Attachment to PTOL-413A Ser. No. 10/691,790

Pidcock et al. discloses a stepped combustor wall. Its barrier member 144 and effusion holes 140 of FIG. 10 were asserted as the claim 5 rail and holes. Page 5, lines 3-5. It is not clear how FIG. 10 (as opposed to FIG. 9) relates to FIG. 7

FIG. 7

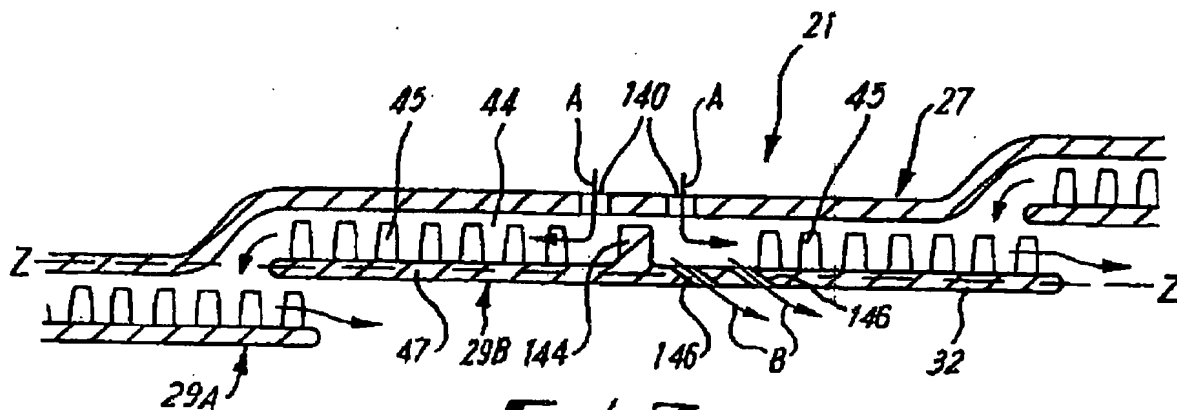
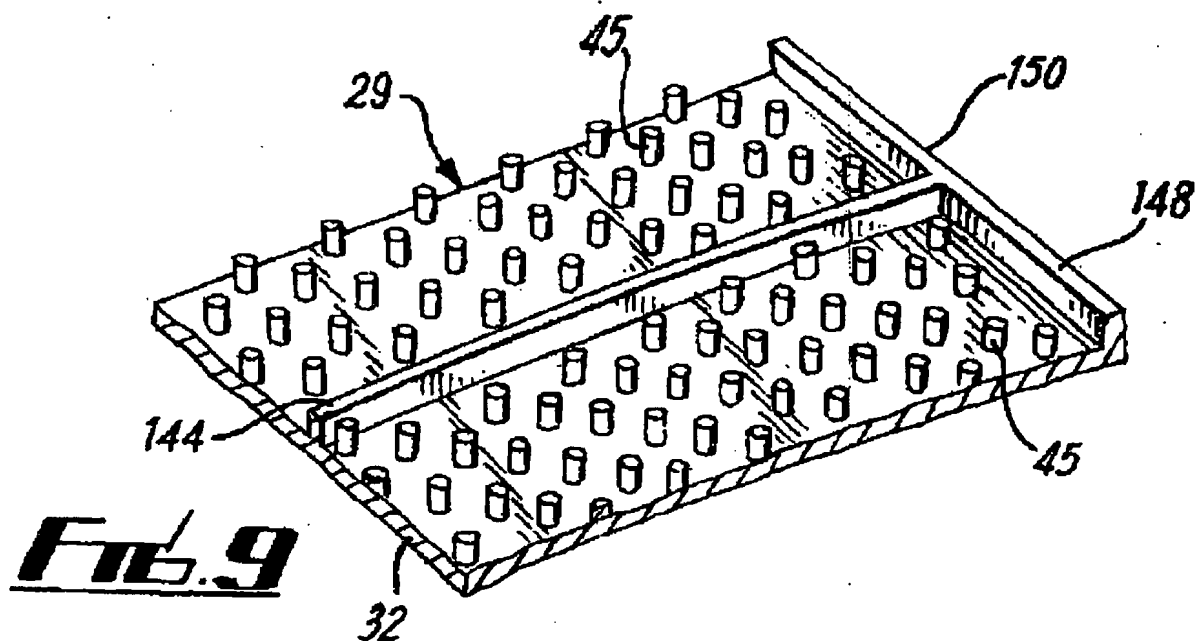
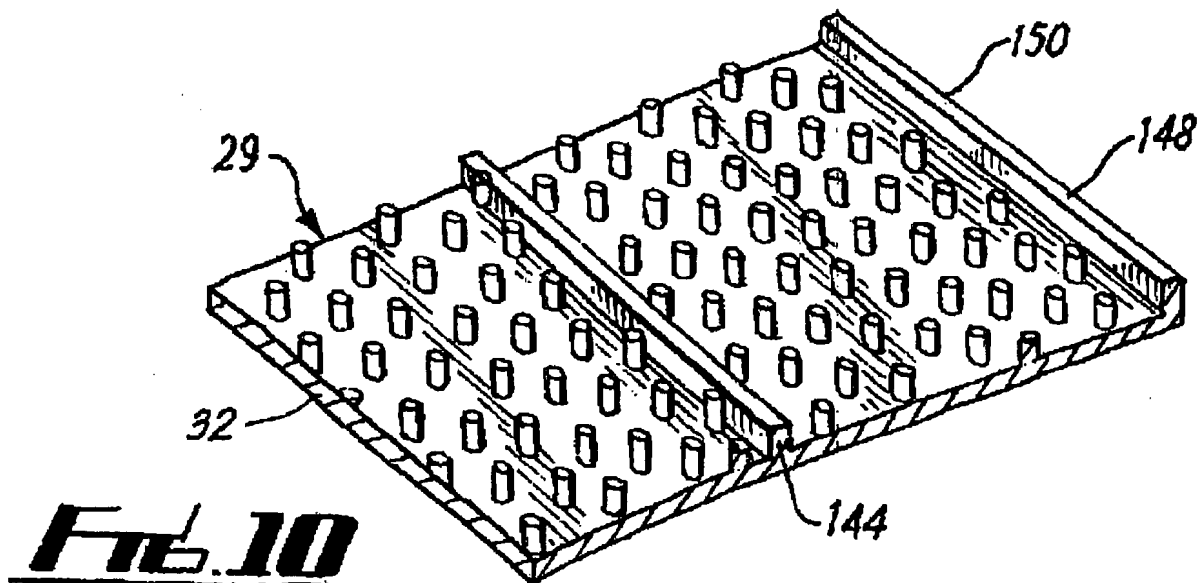
dimensions? Wouldn't the hole 140 of Pidcock et al. then be behind the elements 100a? In this vein, as is clearly shown in FIGS. 7&8 of Pidcock et al., there is no reason to believe optimization would yield the claimed dimensions. FIGS. 7&8 clearly show a large distance effective to have many rows of intervening pedestals.

Fig. 16

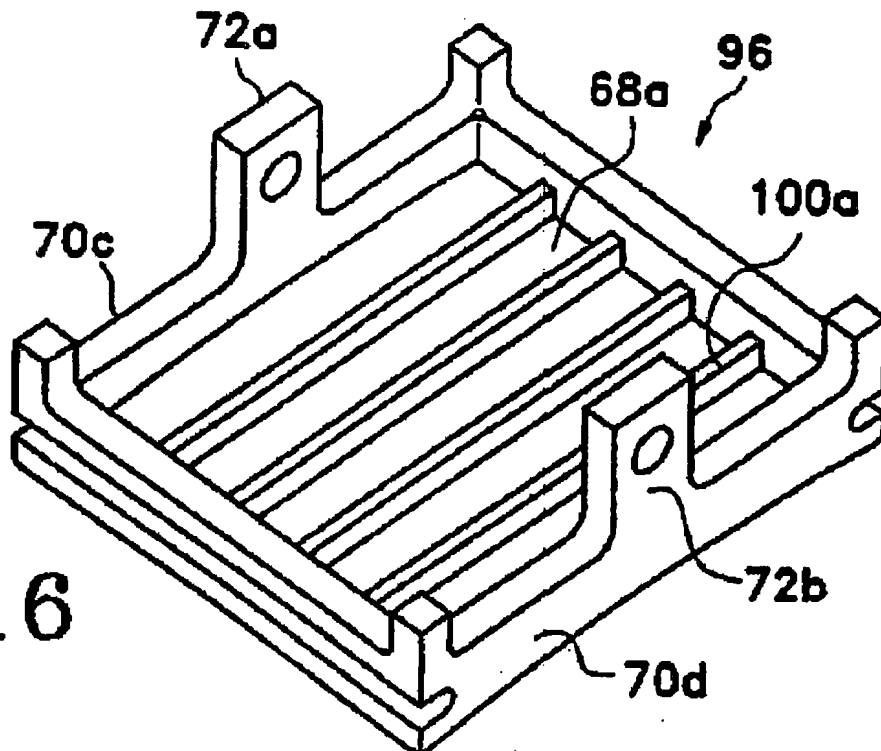
Halila discloses another particular combustor construction. The Office action pointed to FIG. 16 elements 100a which appear to be internal rails. Page 5, lines 3-5.

As noted above, elements 100a are internal rails within a perimeter rail. What basis is there for so selective and adoption?

This emphasizes that the exact nature of the combination has not sufficiently been articulated by the Office. It appears the Office intends to replace the posts 45 of Pidcock et al. with elements 100a of Halila while preserving element 44. Is this correct? What are the relevant
